**Review study on Commission  
Regulation (EC) no 327/2011**  
EVIA Comments to  
*VHK discussion document 21<sup>st</sup> Nov 2014*

The European Ventilation Industry Association welcomes the VHK discussion document dated 21<sup>st</sup> November 2014 regarding the review of regulation 327/2011. We note that the consultant, on behalf of the Commission, has taken into consideration many of the problems, request and suggestions from the European Fan industry. The industry still has some concerns particularly with the proposed slopes and limits.

Graph of forward curved fans showing proposed new limit of N52 (static)

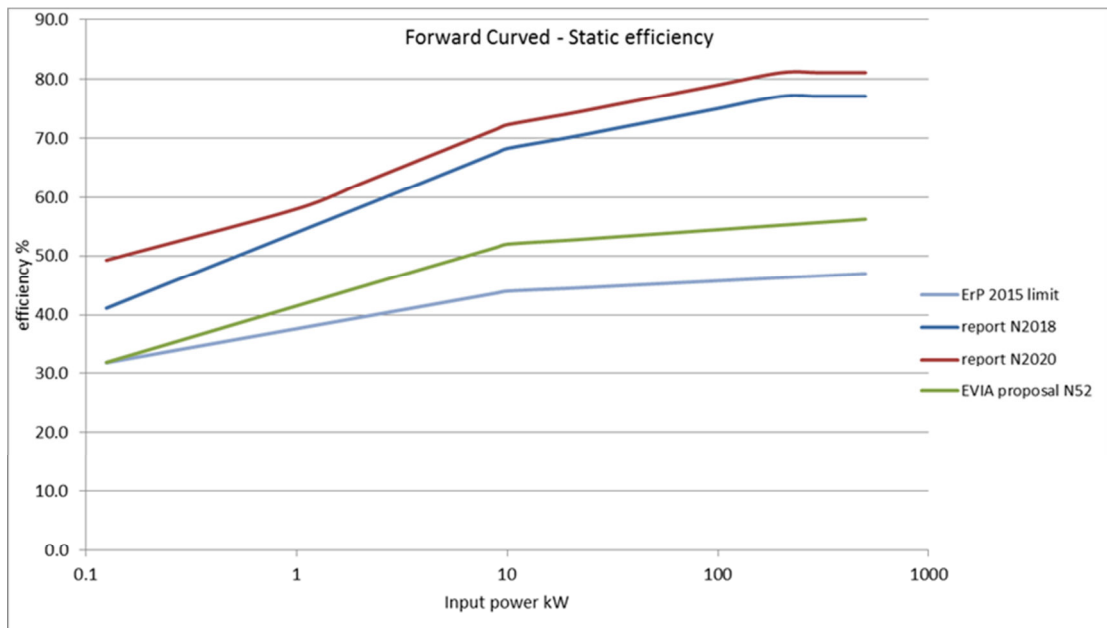
The proposed level for centrifugal fans will result in the removal of forward curved fans from the market. We do not agree with the statement that forward curved fans offer no unique qualities that cannot be reached with a backward curved fan. The forward curved fan has a higher power density and improved subjective acoustic characteristics and therefore demonstrates an environmental advantage over the backward curved centrifugal.

We suggest keeping a separate limit with a change of slope; e.g. use the backward curved slope and a level of N52 (static) for 2020. This has a small increase for the small fans and a large increase for 10kW and above. This recognises the unique high power density small forward curved fans provide the market place and the environment. The very high level of the slope at 10kW will remove the majority of forward curved fans and reflects the market place where these machines do not offer unique qualities over and above backward curves.

An interim slope for 2018 will be too great an impact on the industry. If these revisions come into force in 2016 then the industry will need at least three to four years to develop the technology.

The proposed slope is simpler than that proposed in this report and simplifies the current regulation as there will be only one slope for all fan types, just with different N values.

Graph of axial fans showing proposed new limit of N48 (static)

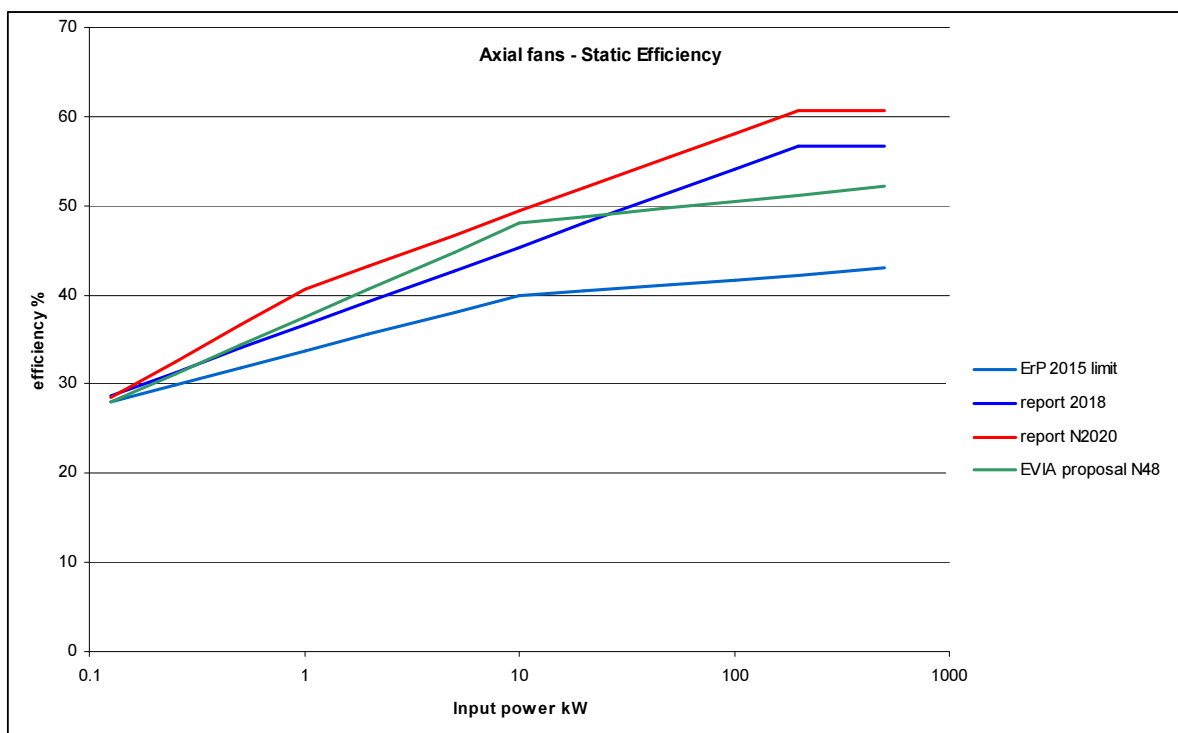
The proposed slope is much too high and would be a severe impact on the industry. We recognise there is room for improvement and propose the same slope as centrifugal fans with an N value of N48 (static) for 2020.

An interim slope for 2018 will be too great an impact on the industry. If these revisions come into force in 2016 then the industry will need at least three to four years to develop the technology.

We propose to use the same slope as the centrifugal and mixed flow fans of the current regulation i.e.  $4.56 \cdot \ln(P) - 10.5 + N$  and  $1.1 \cdot \ln(P) - 2.6 + N$ . This will simplify current regulations resulting in one slope for all fans. It provides a simplification to the proposal in the report. It will deliver significant energy savings.

As previously stated, the difference between static and total limits of the current regulation is too great. The difference between the 2013 static and total limits was 14, which increased to 18 for 2015 and is unchanged in the discussion document proposal. The difference between the 2015 static and total limits for mixed flow is 12 and is reduced to 10 in the discussion document proposal. Similarly for centrifugal fans, the 2015 difference of 3 has been reduced to 2 for 2020. We agree that there should be a distinction between static and total values for axial fans, but this should be a maximum of 14.

We would propose that the total figure for axial fans is N62 for 2020, which still provides a significant stretch over the 2015 limit.
